**HARDY COUNTY RURAL DEVELOPMENT AUTHORITY
HARDY COUNTY, WEST VIRGINIA**

AMERICAN WOODMARK INDUSTRIAL ACCESS ROAD

ADDENDUM #1

THRASHER PROJECT #030-2970

HARDY CO. RURAL DEVELOPMENT AUTHORITY
 CONSTRUCTION PLANS FOR THE
 INDUSTRIAL ACCESS ROAD
 HARDY COUNTY, WEST VIRGINIA
 QUANTITIES

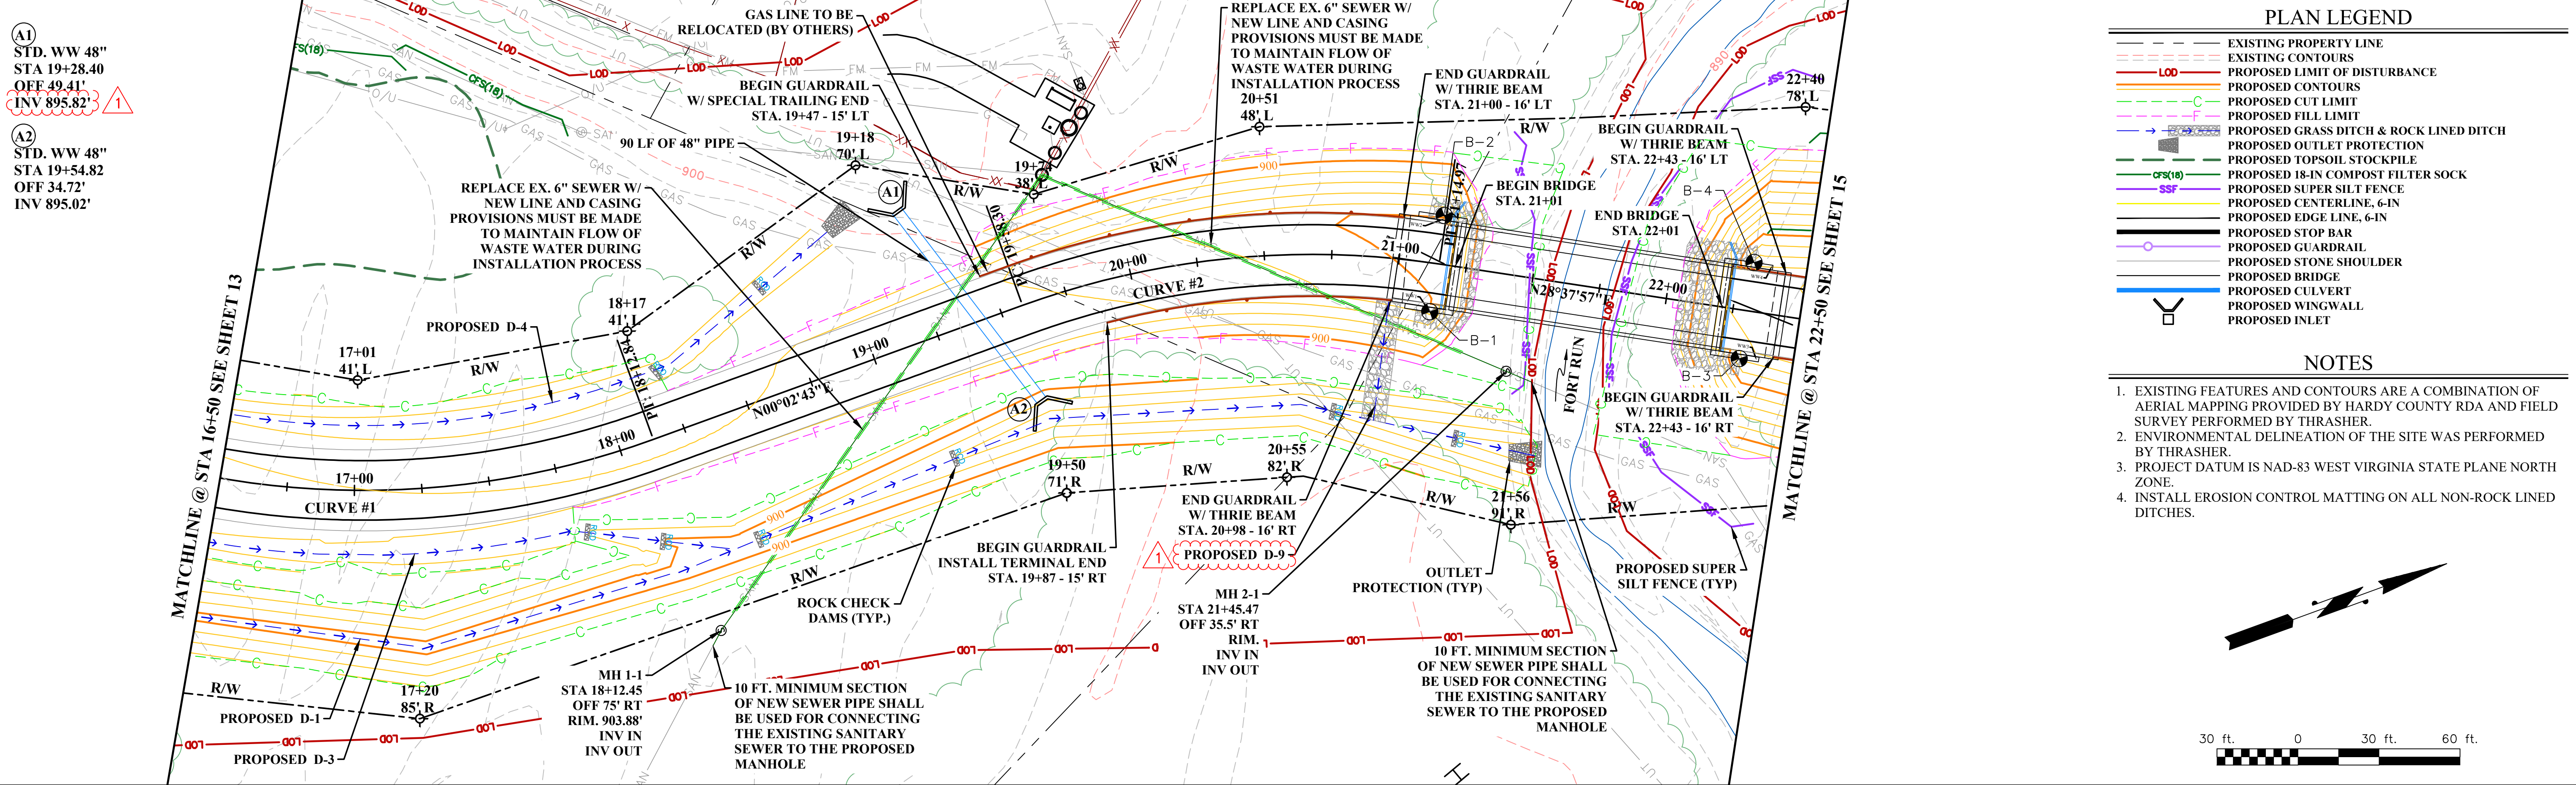
1. Cover Sheet – Sheet Index was updated to add Plan Sheet 18.1
2. Plan Sheet 4 – updated quantities
3. Plan Sheet 14 – updated wingwall invert elevation and added channel D-9
4. Plan Sheet 18 – updated the 48” RCP profile
5. Plan Sheet 18.1 – plan sheet added
6. Plan Sheet 29 – replace the concrete block flume with rip rap lined ditch
7. Plan Sheet 30 – updated bridge notes

The ditch lining material is denoted in the "Remarks" column of the Ditch Schedule on Plan Sheet 4.

NO.	BY	DATE	DESCRIPTION
1	RBM	10.13.2022	ADDENDUM 1 - UPDATED QUANTITIES

HARDY CO. RURAL DEVELOPMENT AUTHORITY
 CONSTRUCTION PLANS FOR THE
 INDUSTRIAL ACCESS ROAD
 HARDY COUNTY, WEST VIRGINIA
 ROAD PLAN AND PROFILE

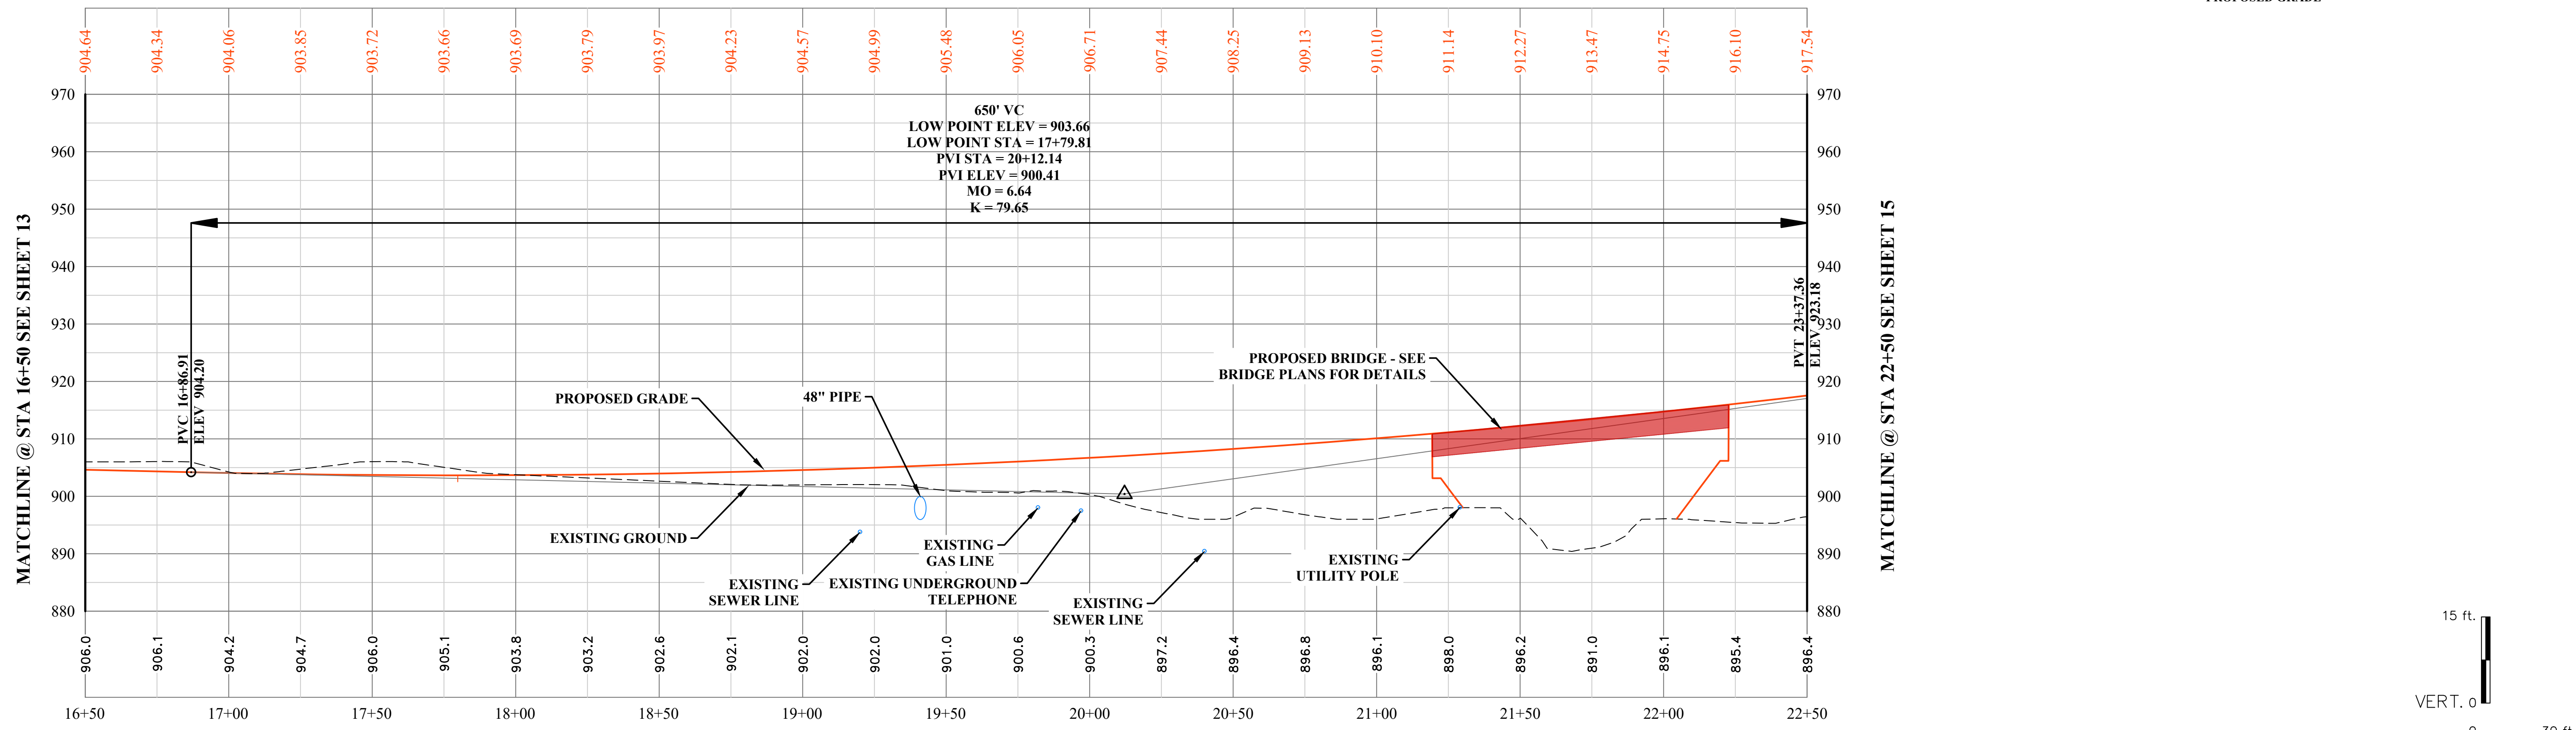
The sanitary sewer and encasement shall be completed along the lines provide on Sheet 14. The Bid Form has been revised to reflect the addition of 2 manholes, sanitary sewer, and steel encasement. The encasement is planned for under the roadway sections and adjacent fill slopes.

The concrete flume has been removed from the construction drawings and replaced with a rip rap lined ditch. See updated sheets 14 and 29.

This is the 48" RCP pipe shown on plan sheet 14. Sheet 18 has been updated.

NO.	BY	DATE	DESCRIPTION
1	RFM	10.13.2022	ADDENDUM 1 - REVISED WINGWALL INVERT & ADDED CHANNEL D-9

HARDY CO. RURAL DEVELOPMENT AUTHORITY
CONSTRUCTION PLANS FOR THE
INDUSTRIAL ACCESS ROAD
HARDY COUNTY, WEST VIRGINIA
STORM PROFILE

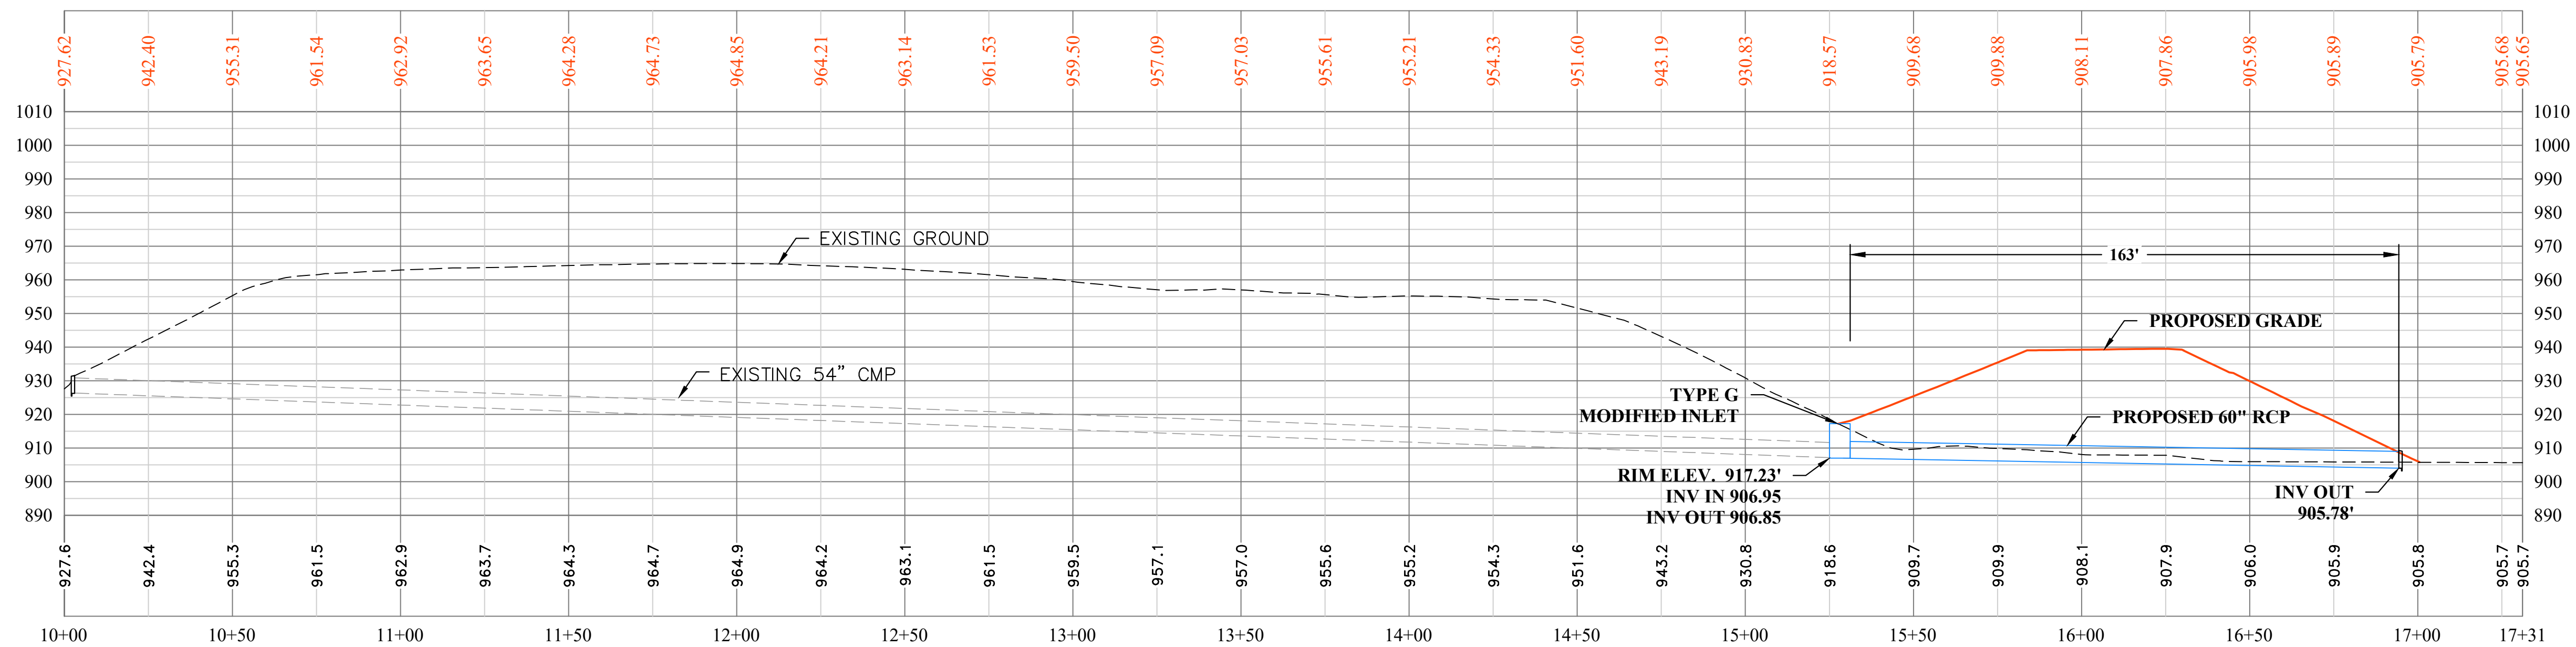
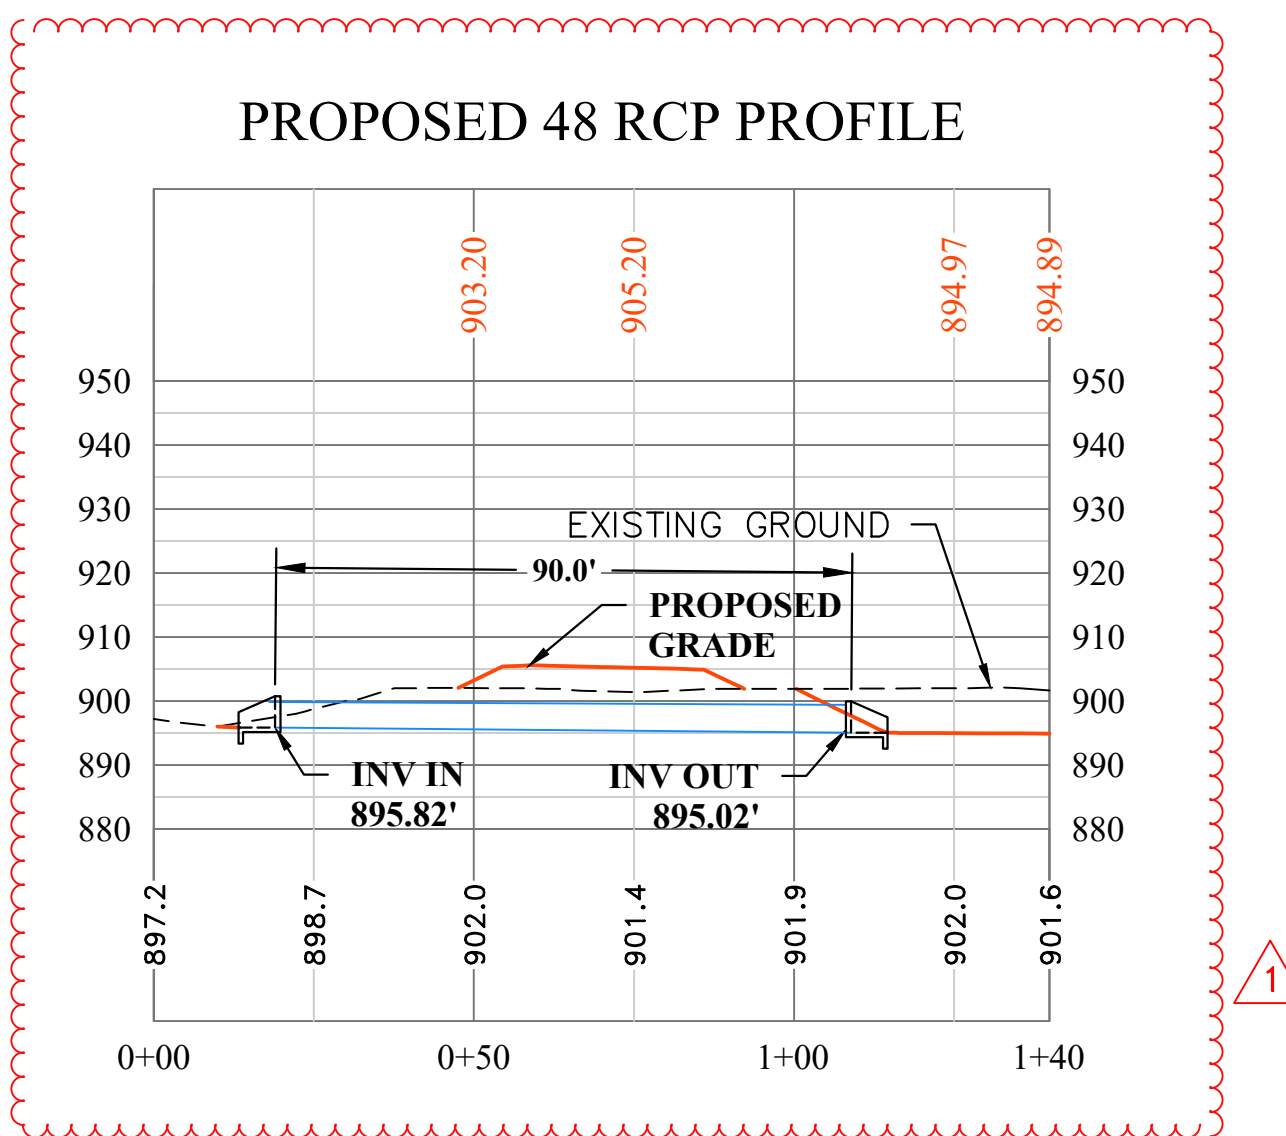
Sheet 18 contains a profile for a "Stream Connection Ditch." The location and pipe size is not indicated. What size and type of pipe are required for this and where is the work located?

THE INFORMATION CONTAINED HEREIN IS THE SOLE PROPERTY OF THE THRASHER GROUP, INC. REPRODUCTION OF THESE DOCUMENTS IN WHOLE OR IN PART, FOR ANY REASON WITHOUT PRIOR WRITTEN PERMISSION, IS STRICTLY PROHIBITED. COPYRIGHT © 2021 THE THRASHER GROUP, INC.			
NO.	BY	DATE	DESCRIPTION
1	RFM	10.13.2022	ADDENDUM 1 - UPDATED 48" RCP PROFILE
